## SYDNEY NORTH PLANNING PANEL SUPPLEMENTARY ASSESSMENT REPORT

<b>Panel Reference</b>	2015SYW189
<b>DA Number</b>	DA0418/15
<b>LGA</b>	Ku-ring-gai
<b>Proposed Development</b>	Demolish structures (except dwelling at 25 Bushlands Avenue) and construct a residential care facility, basement parking and landscaping works under the provisions of SEPP (Housing for Seniors or People with a Disability) 2004.
<b>Street Address</b>	25, 25A and 27 Bushlands Avenue, Gordon
<b>Applicant</b>	Australian Nursing Home Foundation C/O Mark Boffa
<b>Owner</b>	Ms Mei Mei Tse, Mr Bernard Tse, Ms Monica Chu, Mr Andrew Gock, Ms Ellen Louie
<b>Number of Submissions</b>	Original DA: 108 submissions and a petition with 11 signatures objecting to the proposal. 227 submissions (predominantly form letters) and a petition with 8,803 signatures in support of the proposal.
	Amended DA: 64 submissions objecting to the proposal and 1 submission in support
	Amended DA in response to SNPP deferral: 31 submissions

<b>consideration</b>	
<b>Recommendation</b>	Refusal
<b>Report prepared by</b>	Jonathan Goodwill – Executive Assessment Officer
<b>Report date</b>	5 July 2017

**Figure 2 - extract from amended west elevation**

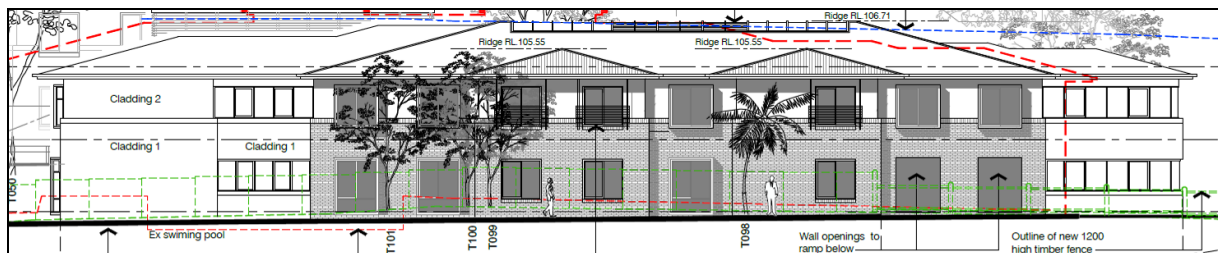
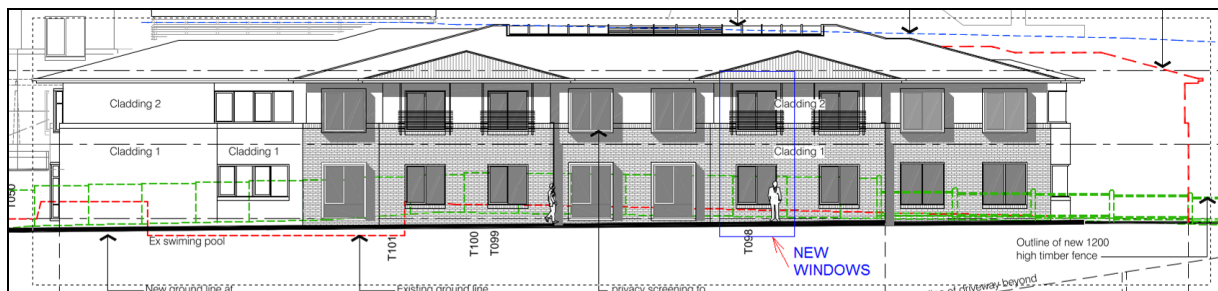
*1. The western building should be set back to the predominant alignment of the existing heritage dwelling on the site.*

The street setback of the western building has been increased by 5.31m, from 14.6m to 19.91m. The street setback of the heritage item No. 25 Bushlands Avenue is 19.2m.

The number of beds in the West Wing has been reduced by four. One window (with a privacy screen) has been added to the western elevation at the first floor level and one window has been added to the western elevation at the ground floor level. The projecting bay at the northern end of the elevation has been moved 3m north. There is no change to the minimum side setback of 3.5m.

**Figure 3 - the red shading represents the 25m<sup>2</sup> increase to the area of the courtyard**

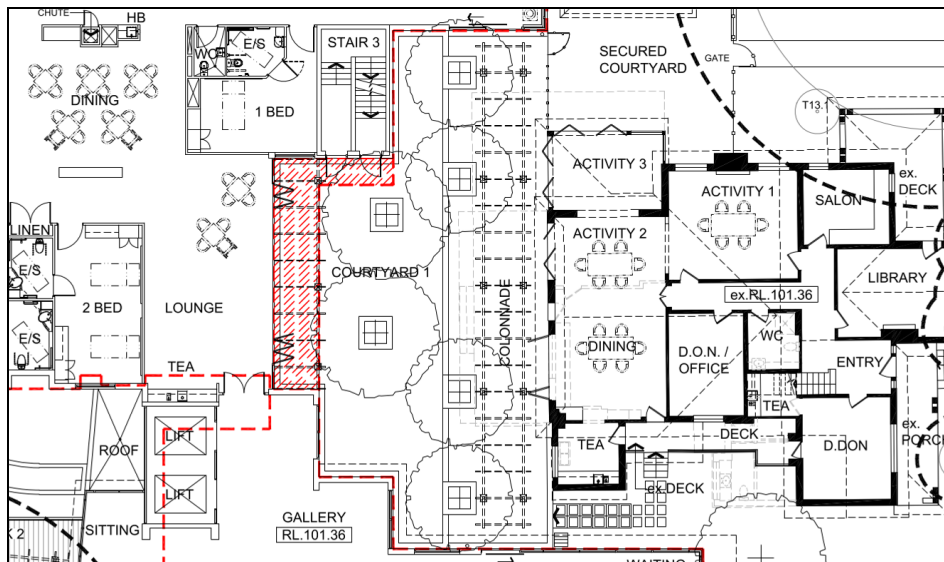
*2. Courtyard 1 at the rear of the existing heritage item should be increased in size and allow deep soil to allow the growth of large, centrally located (15m plus) trees to maintain the backdrop to the heritage item. This may require the design of the basements to be amended.*

Courtyard 1 has been widened by 2m in a north-south direction by reducing the depth of the lounge room and 1.3m in an east-west direction by moving Stair 3. A glass roof pergola has been added to the northern side of the courtyard in the area previously occupied by the lounge room and the stairs. The area of the courtyard has been increased by 25m<sup>2</sup>, however 21m<sup>2</sup> of the additional area is covered by the pergola.

**Figure 5 – extract from amended landscape plan**

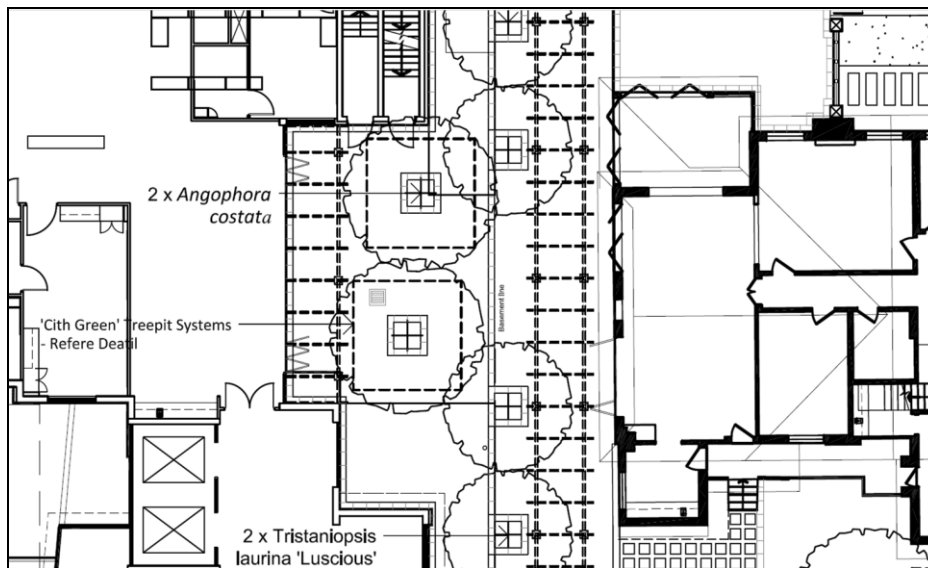
*The proposed courtyard at the rear of the heritage residence is considered of inadequate size to support the proposed two canopy trees. The building setbacks (approx. 2.6m and 3.5m) from the rear two storey building are insufficient as the mature spread of the proposed Angophora costata (Sydney Red Gum) is approximately 15-20 metres diameter (6 metres diam. shown). To ensure long term viability of the proposed trees, a minimum 5 metres setback from buildings is recommended. If the Tristania plantings were removed, it would provide space for greater setbacks for two canopy trees of a different species and with a more upright form. Alternatively, one canopy tree at the rear of the heritage dwelling centrally located as a specimen within a slightly larger rectangle of garden would achieve the desired visual outcomes. Similarly the removal of the Tristania would also benefit the viability of a single taller canopy tree.*

*The Tree Pit Detail is not supported for the following reasons:*

- i. The proposed root barrier as part of the tree pit is considered unnecessary on the western side and beneath the planter considering the proximity of concrete basement walls. The proposed dimensions of the root barrier are likely to compromise the long term viability of the proposed tree planting.*
- ii. The proposed drainage medium should be associated with the basement slab to achieve minimum soil volumes to support proposed mature tree (refer Control 7(i) Part 23.5, KDCP in regards to soil volumes of large trees on slab).*
- iii. Crushed granite is unsuitable for locally occurring vegetation and would be preferable to be substituted with drainage cells.*

The landscape plan has been amended to include the construction of two tree pits with dimensions of 4m x 4m x 1.8m in the courtyard. Each tree pit is to accommodate an Angophora Costata (Sydney Redgum) with a 75 litres container size at the time of planting. The landscape plan nominates a mature height of 20m and canopy spread of 6m for the selected tree species.

The above issues can be addressed by **Condition 27** in the without prejudice condition set.

**Figure 6 - west elevation of amended roof form – original roof shown as a red dashed line**

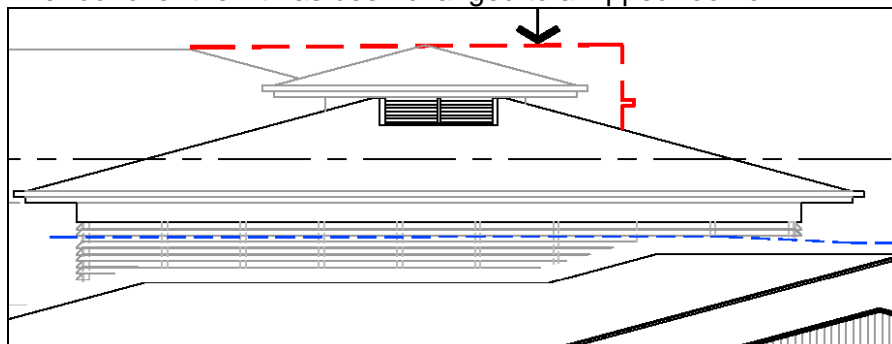
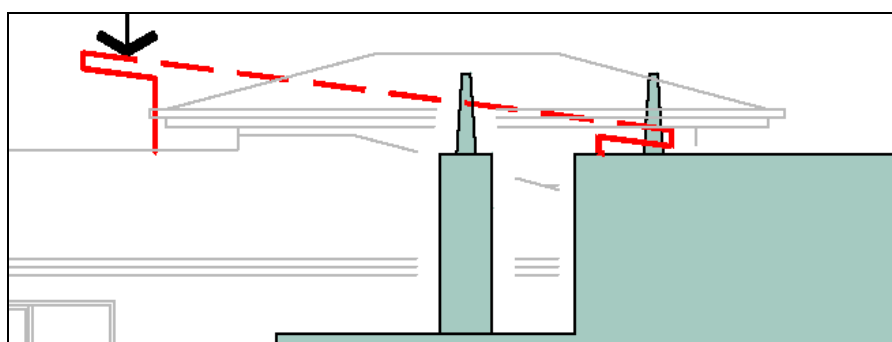
*4. The skillion roof over the lift is to be a traditional hip to match the remainder of the development.*

The roof over the lift has been changed to a hipped roof form.

Figure 8 - setbacks of the East Wing at the rear boundary

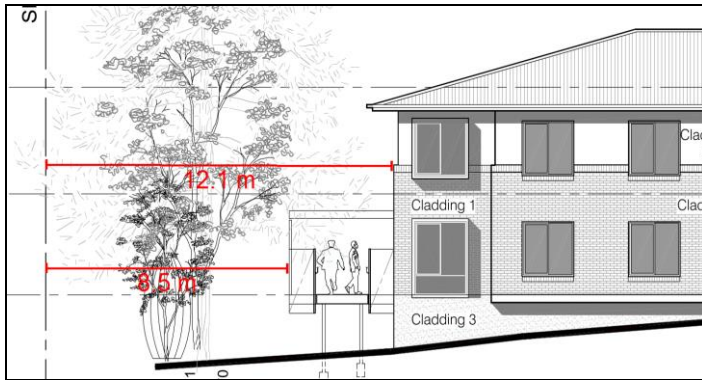
*5. The rear setback is to be increased to 12 metres minimum to reduce the adverse impact on the St Johns Avenue Conservation Area.*

The rear setback has been increased by 5.56m, to 12.1m and a raised deck has been added. The rear setback is greater than 12m. The number of beds in the East Wing has been through changes to the internal layout.

Figure 10 - bus entering

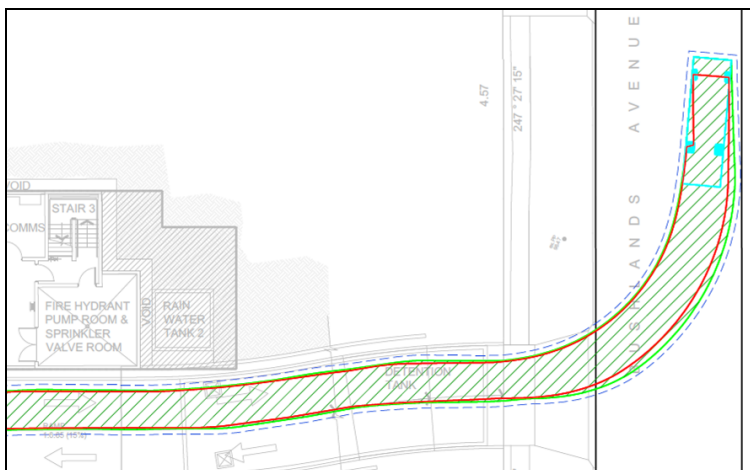
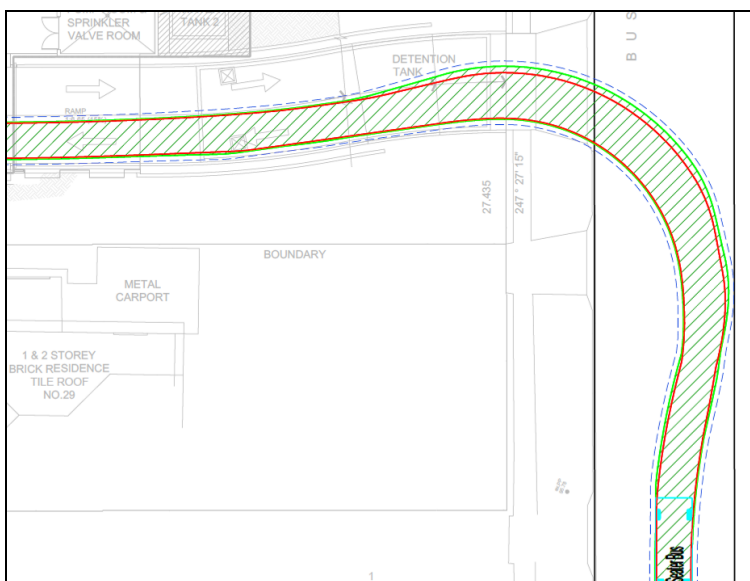
*6. Review and resubmit traffic report to consider the impact of service vehicles and community bus in terms of traffic generation and the adequacy of Bushlands Avenue to safely accommodate the anticipated vehicle movements.*

*Reference is made to AS2890.2:2002 Off-street commercial vehicle facilities. The bus service is defined as a Regular service – Minor road. Section 3.2.4b) of the Standard states "The swept path of the maximum size design vehicle using the facility may be allowed to occupy the entire width (less specified clearances) of a two-way access driveway when the vehicle is entering or leaving the minor road".*

*A template of the bus path was shifted over on the plans of the bus swept path entering and exiting (painted median). If the bus uses the entire width of the driveway at the entry it can avoid crossing the centreline of Bushlands Avenue. (Note the Standard also allows reversing onto or off the street if permitted by the relevant authority).*

An amended Traffic Report has been submitted. The report includes swept path diagrams for a bus entering and exiting the basement. The swept path diagrams show that the bus will need to cross the centre line of Bushlands Avenue in order to enter or exit the basement.

*The traffic report contains turning paths for these vehicles entering and leaving the basement. These manoeuvres can be accommodated within the roadway without encroachment onto the grass verge opposite. Parking of vehicles opposite the site entry is considered to be unlikely to impede access due to the layout of driveways and the low incidence of parking on the verge, however a condition is recommended that the applicant approach the traffic committee with a request for parking restrictions prior to occupation of the development. If the traffic committee is minded to approve the request, the length of the restriction can be determined at that time.*

*The relatively gentle entry ramp gradient will allow for the bus driver and any driver entering or leaving in the opposite direction to see each other. Keeping in mind that the overall traffic generation will be low.*

Figure 11 - Wall height at western elevation. The red dashed line is the existing ground line.

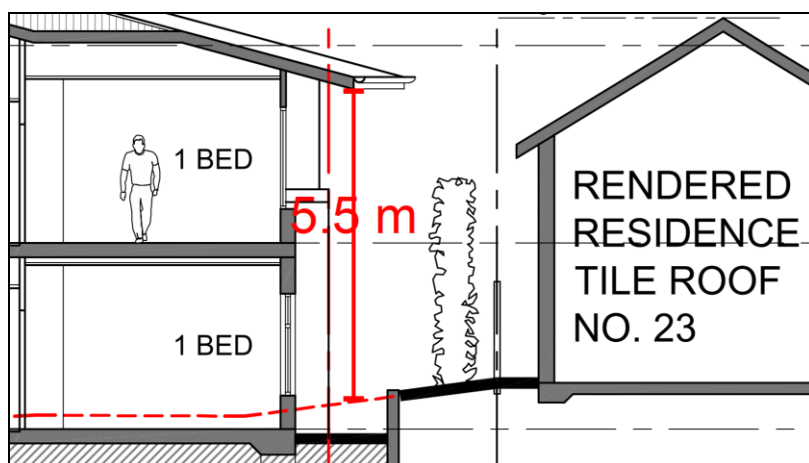
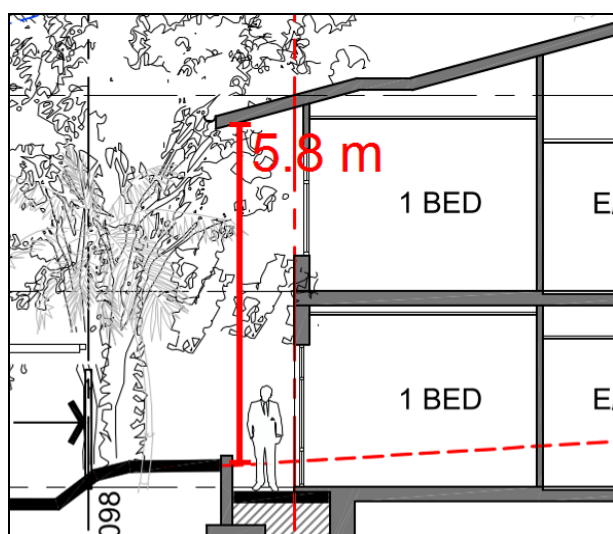
***The side setbacks are inadequate, they should be a minimum of 6m***

Whilst greater side setbacks would be desirable, the proposed setbacks are considered acceptable as the landscaped area of the proposal substantially exceeds the requirement of the SEPP, the floor space ratio of the proposal is significantly less than the FSR standard set by the SEPP of 1:1 and the setbacks are consistent with the streetscape character.

Whilst the length of the side elevations is greater than the streetscape character, appropriate modulation of the built form has been achieved. The height of the side walls has also been minimised by retaining walls adjacent to the side boundaries which allow for finished floor levels that are below the existing ground levels. Despite the two storey height of the building, the retaining walls allow for side walls that have a maximum height of less than 6m.
